Office Action Summary

10/614,268

MCFADDEN, DAVID H.

DETAILED ACTION

Segment of Fig. 6 of Smith (the examiner has added the lead arrow and "colliding gas flows" text)

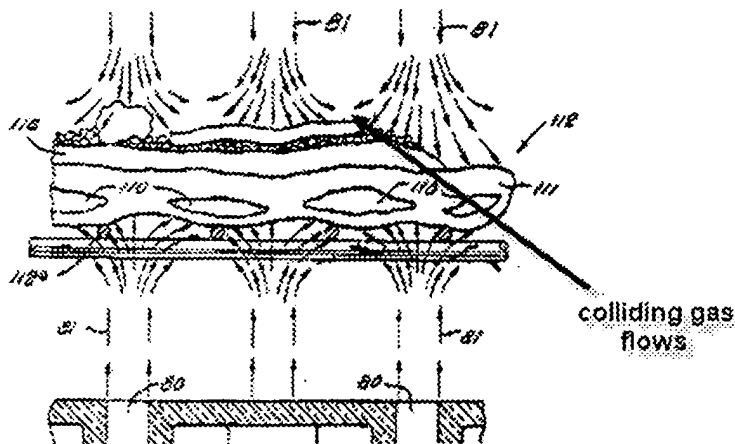
(g) a first gas directing means associated with the conduit means and disposed above the food product (see at least the central upper jet 81 in Fig. 6, which is produced from a tube 90 as shown in Fig. 2 or see the middle tube 126 producing jet 81b of Fig. 8);

(h) a second gas directing means disposed above the food product (see at least the rightmost jet 81 in Fig. 6, which is produced from a tube 90 as shown in Fig. 2 or see the right most tube 126 producing jet 81c in Fig. 8);

In regard to the recitations that the first and second gas directing means are configured to cause gas from these means to collide upon the upper surface of the food product, these recitations are considered present in Smith. Specifically, in describing Fig. 8, Smith notes that the high velocity jets (81) impinge upon the surface of a food product (P) "to provide very rapid heat transfer and very rapid water vapor removal from the surface of the product." (Smith, col. 10, lines 45-51). Further, Smith also describes that the jets (81) after striking a solid surface are "transformed into a turbulent mushroom shaped pressure area" (se col. 1, lines 6-10). The examiner considers that the above noted descriptions suggest that the gas jets from the gas directing means in either Fig. 6 (unshown tubes 90) or Fig. 8 (upper tubes 126) noted above collide with one another as described. The following are segments of Fig. 6 and Fig. 8 to further illustrate what the examiner considers to be the colliding flows.

Segment of Fig. 8 of Smith (the examiner has added the lead arrow and "colliding gas flows" text).

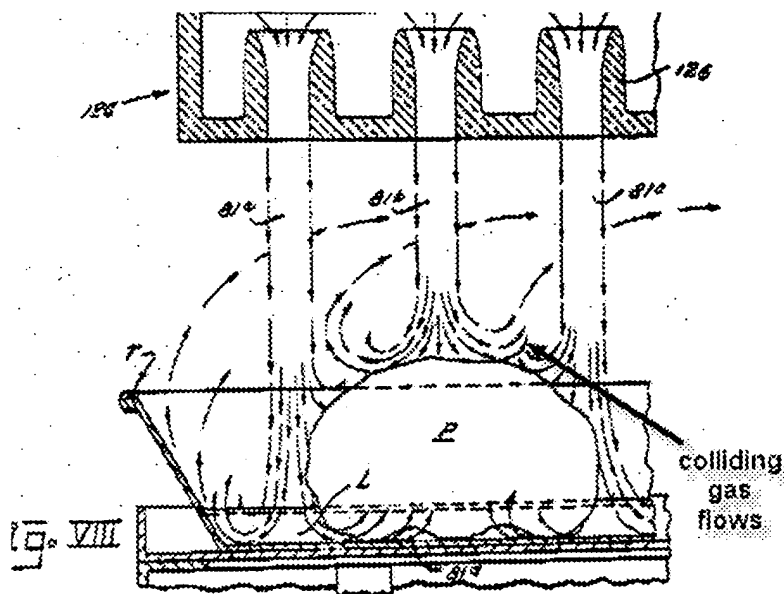
flow over the surface of the food product to an adjacent low pressure area (see col. 8, lines 63-65). In describing Fig. 8, Smith also notes that heat air flows over the food product from areas of high pressure to areas of low pressure to transfer heat to the product (see col. 9, line 65 through col. 10, line 2). Further, Smith also describes that the streamlined jets (81) are transformed into "turbulent mushroom shaped pressure" areas which "effectively heat[s] the underlying surface" of food products (see col. 11, lines 6-10). These turbulent pressure areas are understood to include the air from the jets, which is no longer in streamlined form, but still includes flows of air within this area in order to transfer the heat from the air flows to the food product. These turbulent pressure areas are reasonably understood to include air from adjacent jets flows such that the "turbulent" nature of these zones causes air from these adjacent jets to collide and effectively transfer heat to the food product.
